ATTACHMENT 3 TO AEP:NRC:0896X

PROPOSED REVISED
TECHNICAL SPECIFICATION PAGES

ATTACHMENT 4 TO AEP:NRG:0896X

COOK NUCLEAR PLANT EMERGENCY DIESEL GENERATOR
LOAD-RUN PERFORMANCE AND RELIABILITY
DURING SHORT AND LONG DURATION TEST PERIODS

Figure 1: Plot of $P(t)$

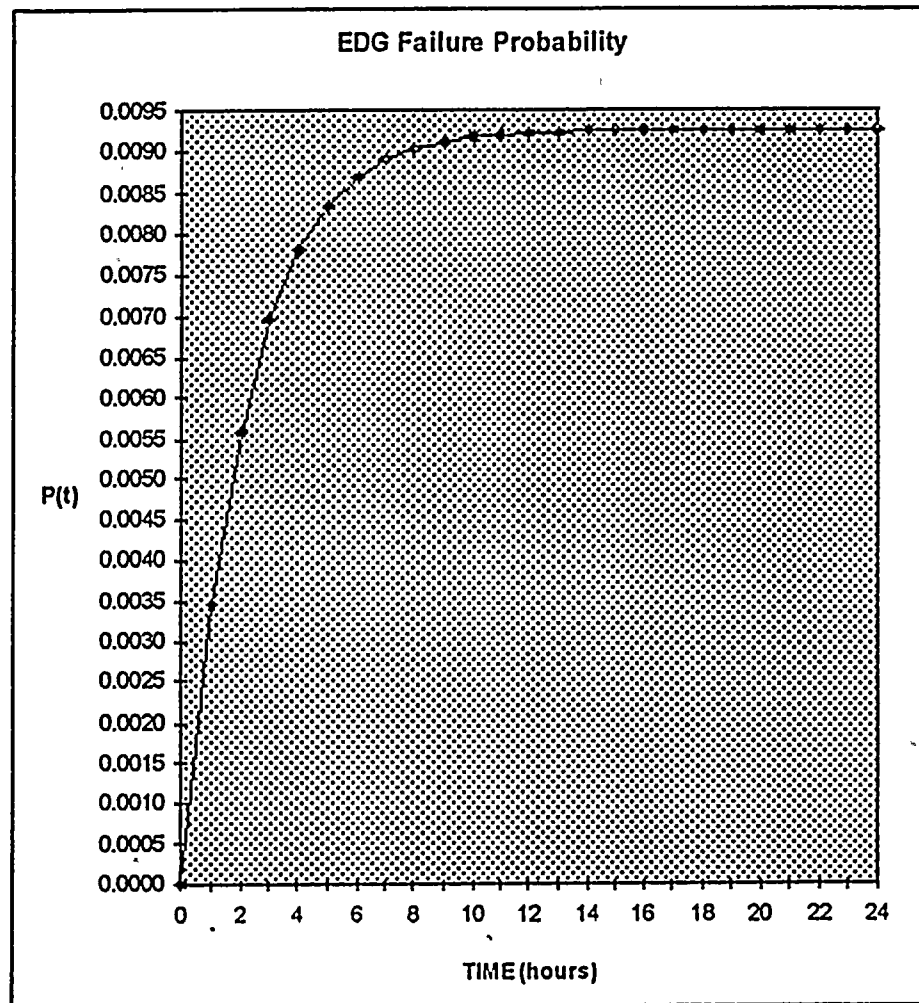
Figure 1 shows that after approximately ten hours the EDG failure probability would increase at a very slow rate (i.e., $dP(t)/dt \approx 0$). To better understand this result and to answer question "b" above, a plot of $P(t)$ normalized by $P(t=24 \text{ hrs})$ is shown below.

Figure 2: EDG Cumulative Failure Probability

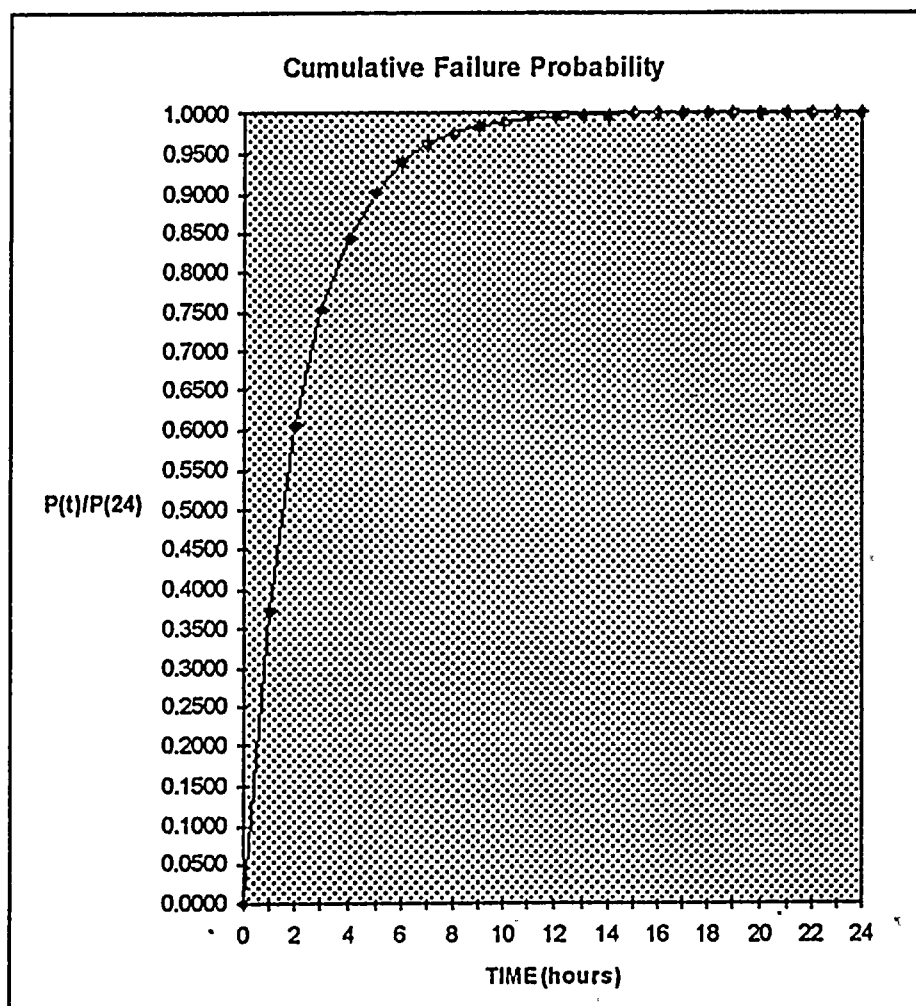
From figure 2, it can be seen that approximately 98% of the failures occur within the first 8 hours while only 60% occur within the first 2 hours of operation. This may be an overly conservative estimation from the standpoint that, at Cook Nuclear Plant, all of the actual observed failures occurred within the first 2 hours of operation.

Therefore, based on actual performance data and related industry-wide surveys, an endurance test duration of $T = 8$ hours is recommended to provide the necessary insight about EDG reliability. Test durations greater than eight hours would not provide a significant operating safety benefit and would only serve to increase cumulative run time and the likelihood of age-related component failures.
